BRATTLEBORO BHF 2000 (17)
US 5 (T.H.1); BRIDGE 7

PROPOSED IMPROVEMENT
BRIDGE PROJECT
TOWN OF BRATTLEBORO
COUNTY OF WINDHAM

PROJECT DESCRIPTION : THE PROJECT SHALL CONSIST OF THE REHABILITATION OF BRIDGE NO.7 ALONG WITH RELATED ROADWAY APPROACH WORK.

RECORD PLANS

CONSTRUCTION SIGN DETAIL (4)

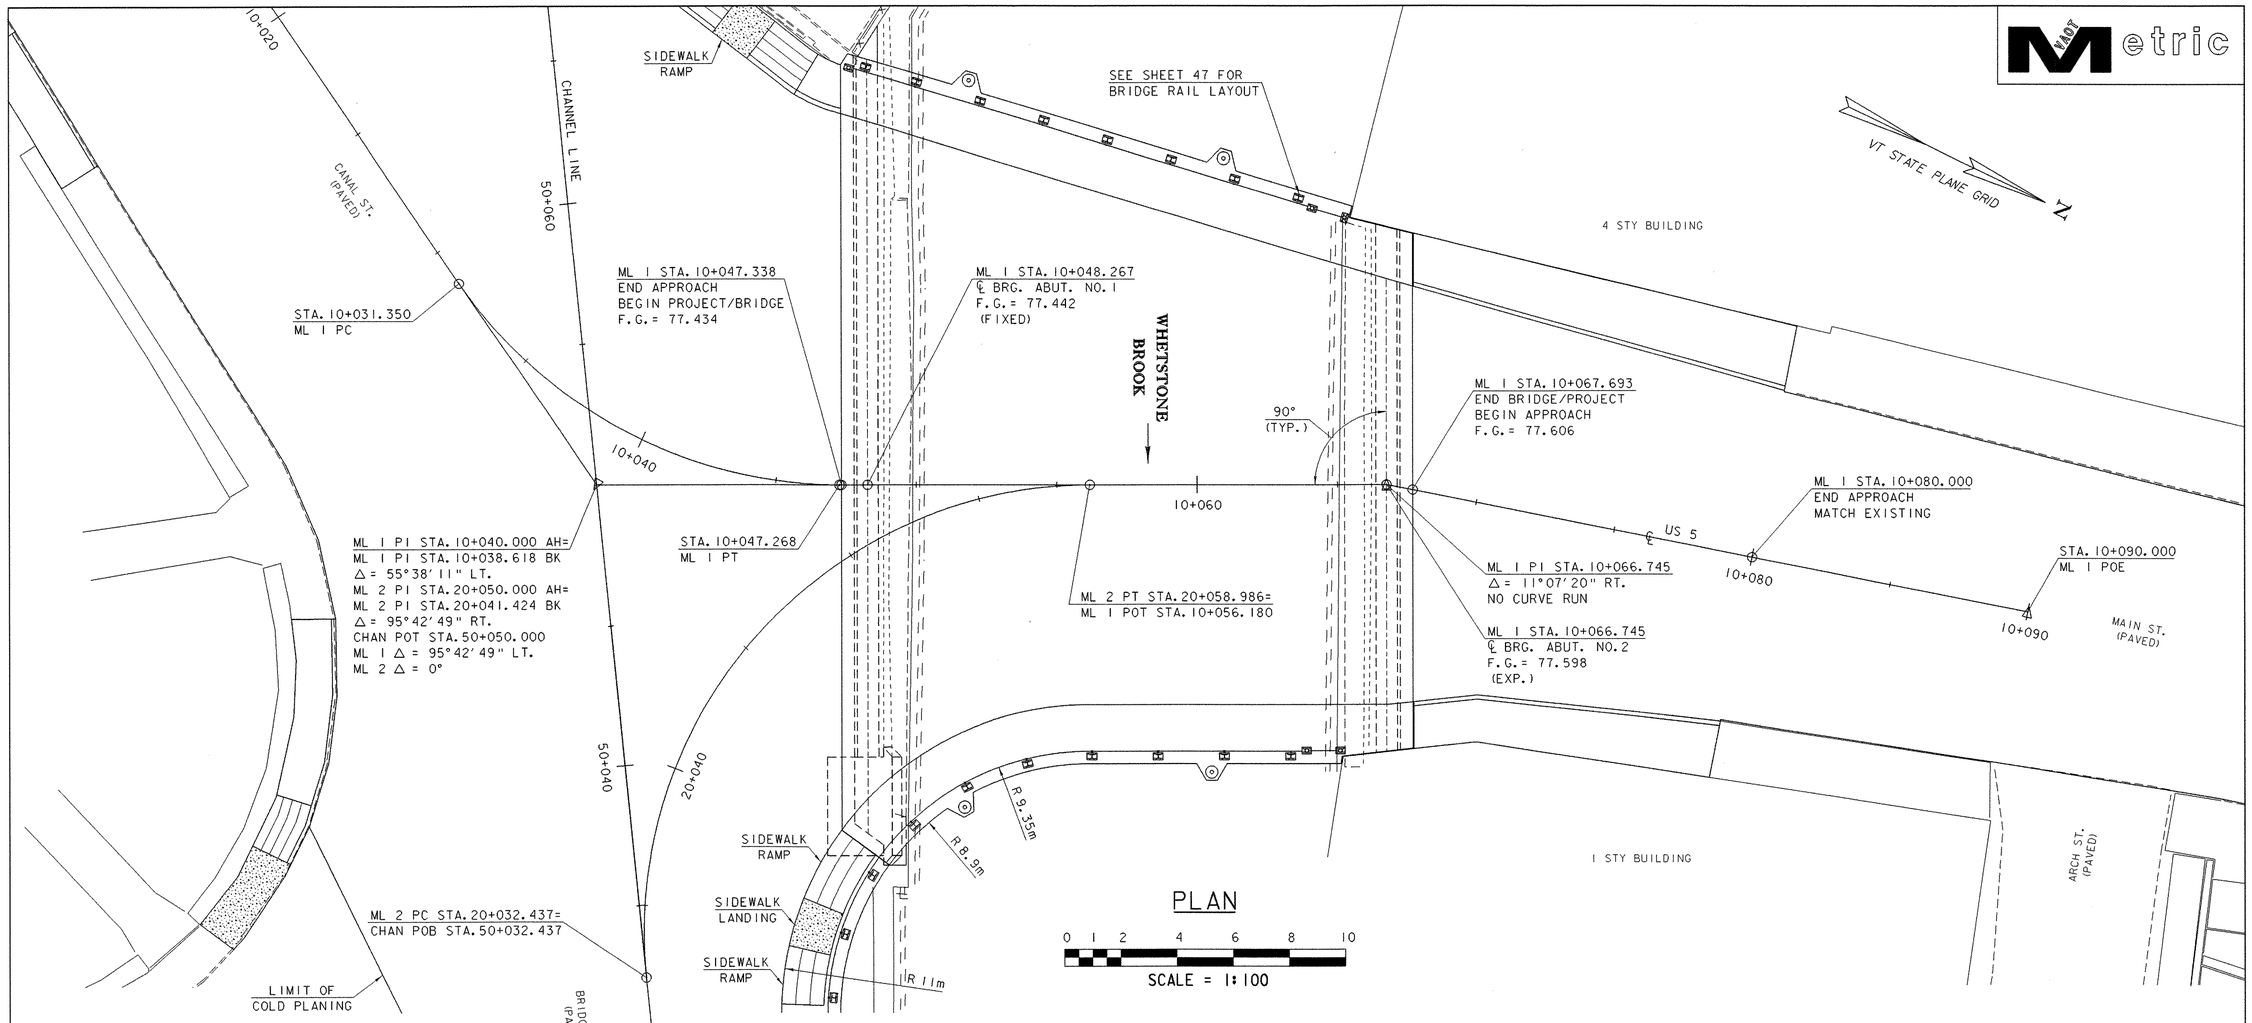
△ Revised by VAOT 3/10/03
Size of Sign Changed

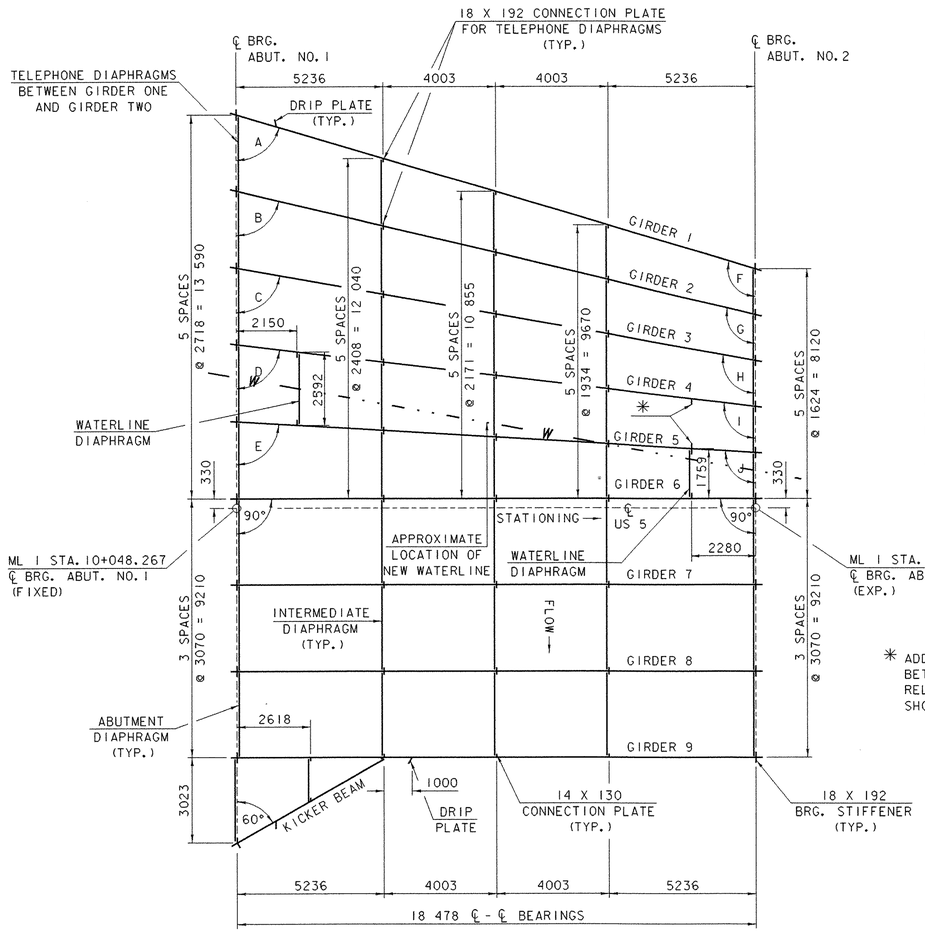
✳ ADDITIONAL WATERLINE DIAPHRAGM CONNECTION PLATES REQUIRED BETWEEN GIRDERS 4 AND 5 IN ORDER TO ACCOMMODATE WATERLINE RELOCATION AS DETERMINED IN THE FIELD. (SAME LOCATION AS SHOWN BETWEEN GIRDERS 5 AND 6)

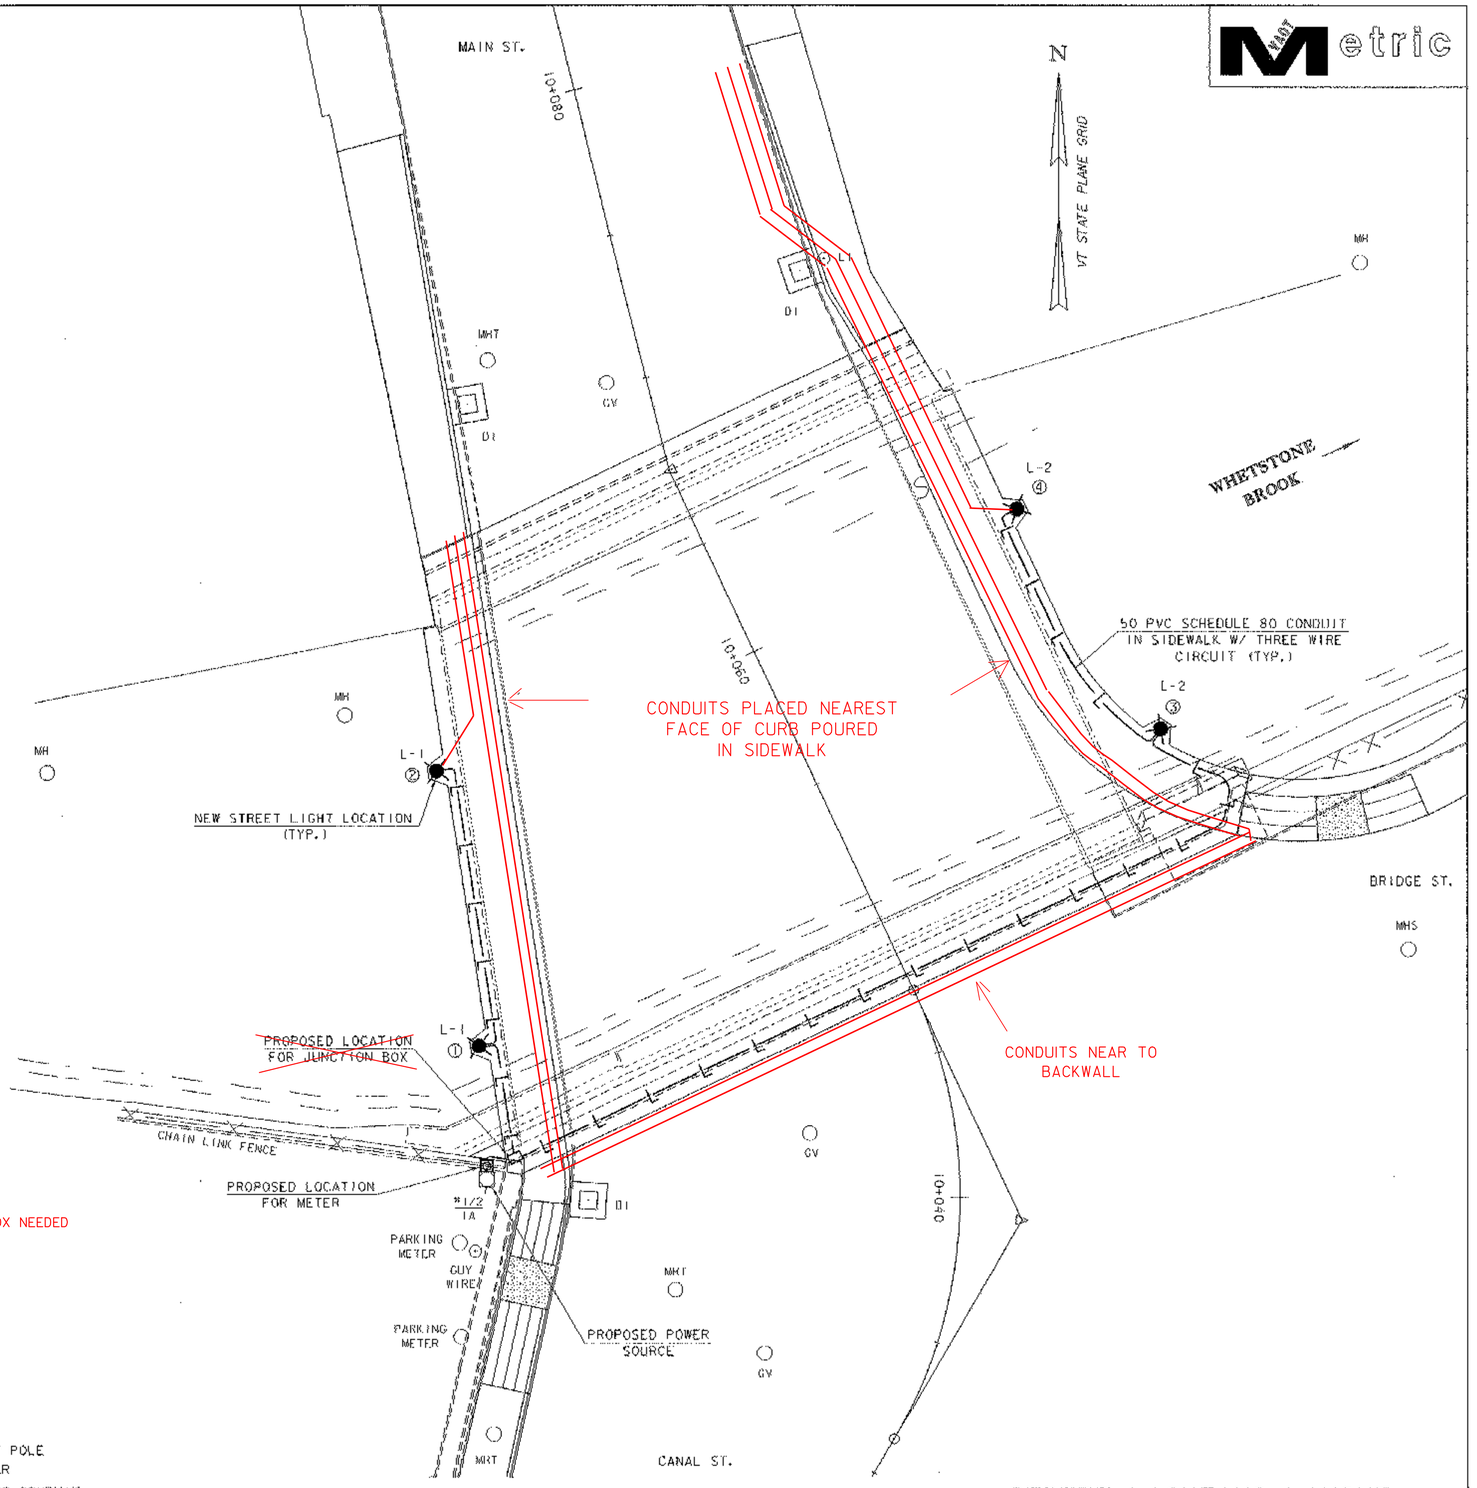
3. INSTALL ALL ~~JUNCTION BOXES,~~ THE CONDUIT, PHOTOCELL AND WIRING AS DETAILED ON PLAN DRAWINGS. NO JUNCTION BOX NEEDED

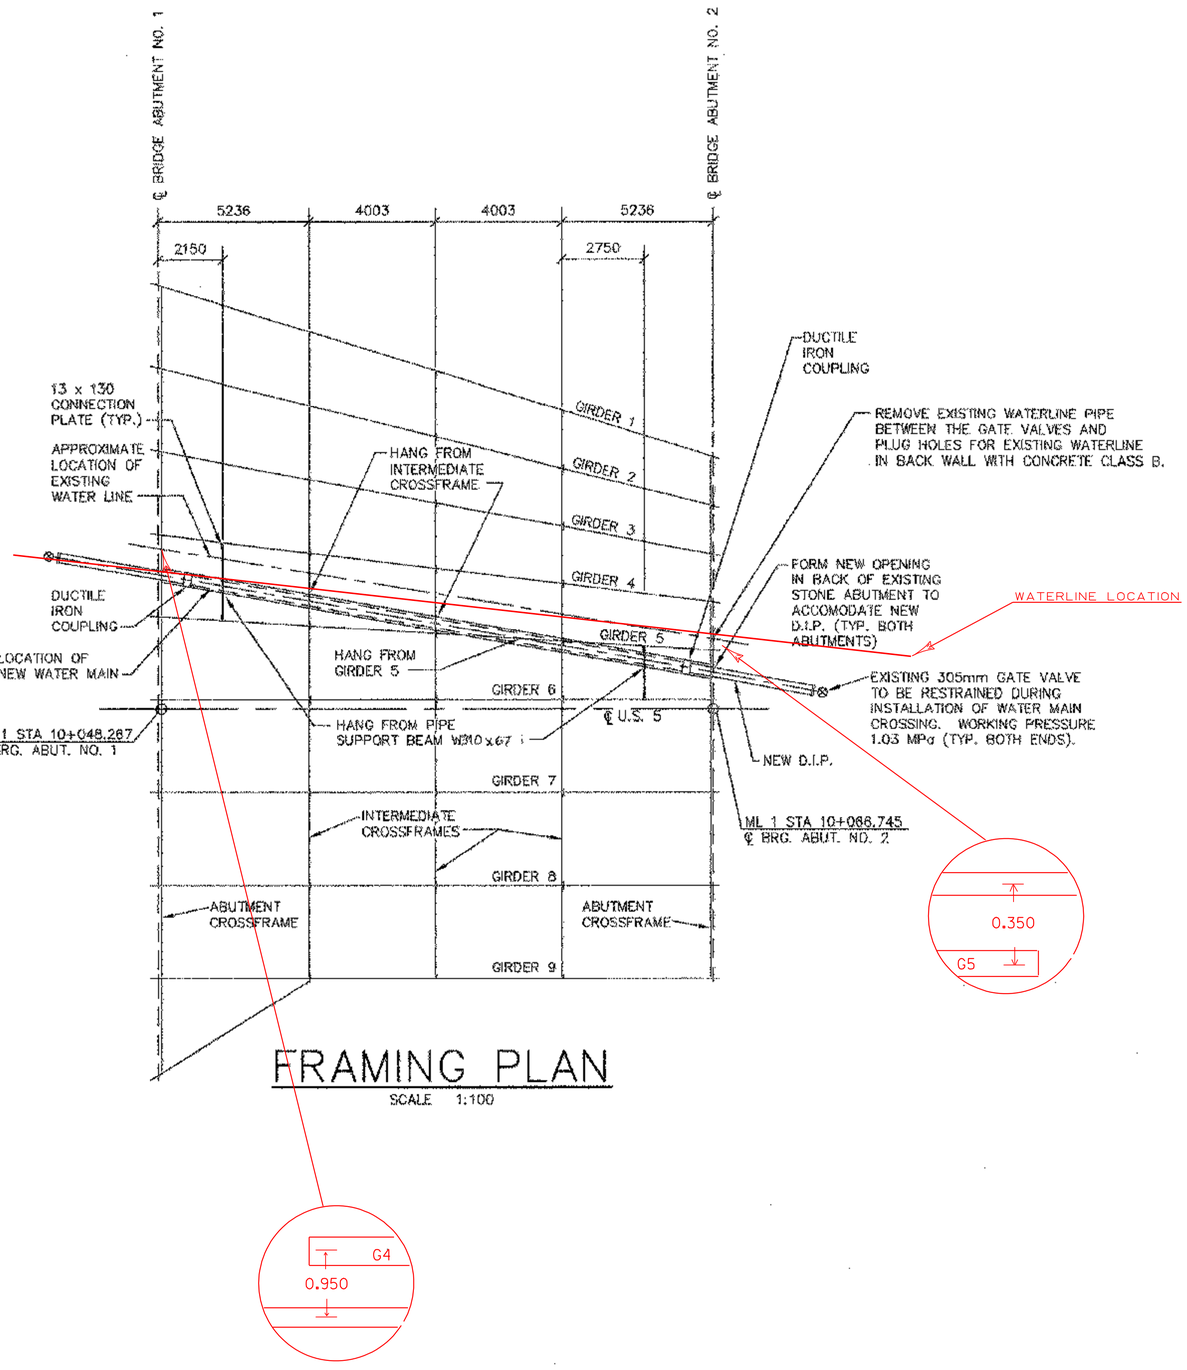
* SEE DAILY REPORT #46, DATED 6/18/03
UNABLE TO CONNECT THIS CONDUIT -
WOULD HAVE HAD TO CUT BEARING PLATE
OK'D BY NEIL SNYDER OF VERIZON

ORNAMENTAL RAIL DETAILS (1)

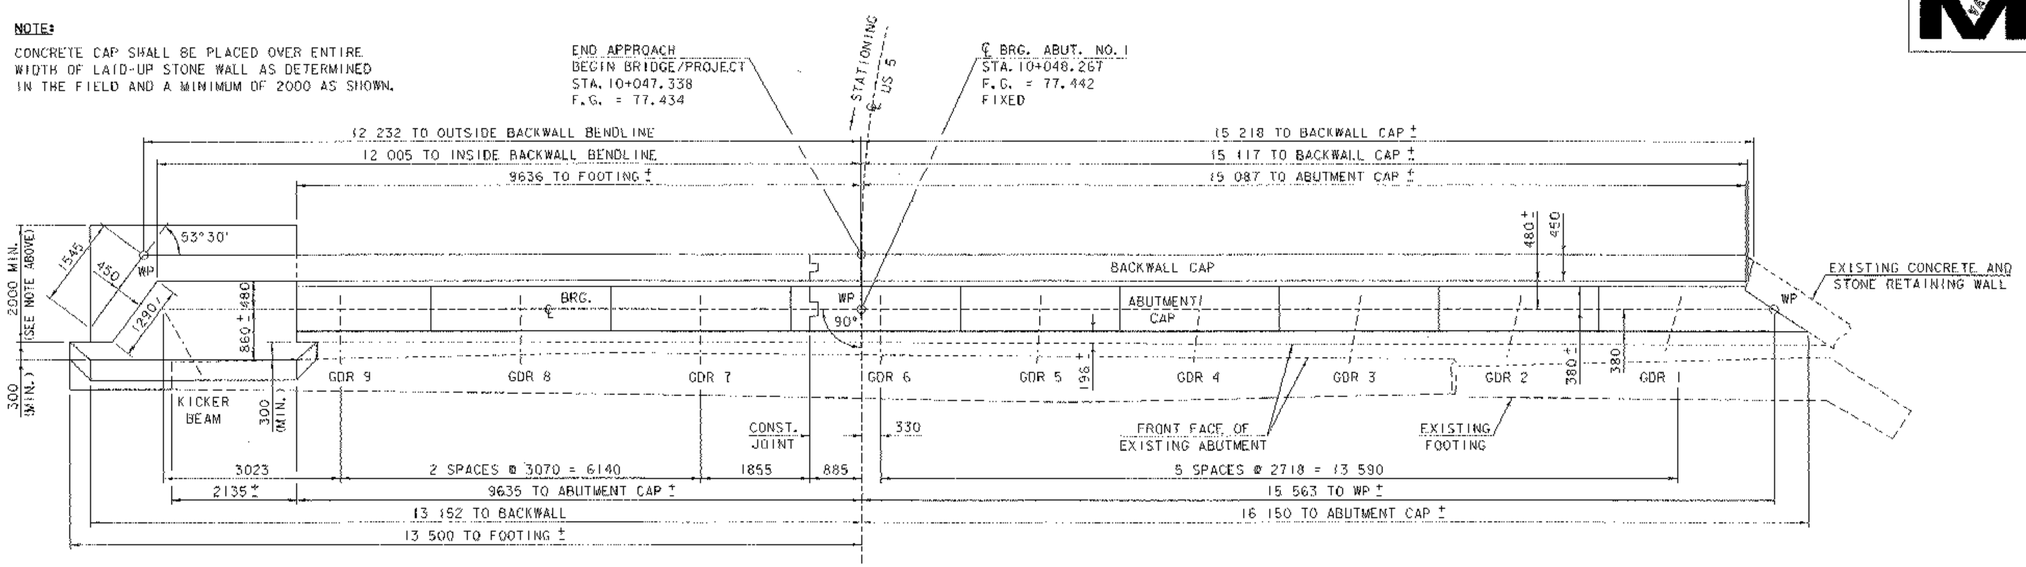
CAST BOLTS HAD DIFFERENT BOLT PATTERN
HAD TO CUT BOLTS POURED IN PLACE, DRILL
& EPOXY NEW ONES IN PLACE
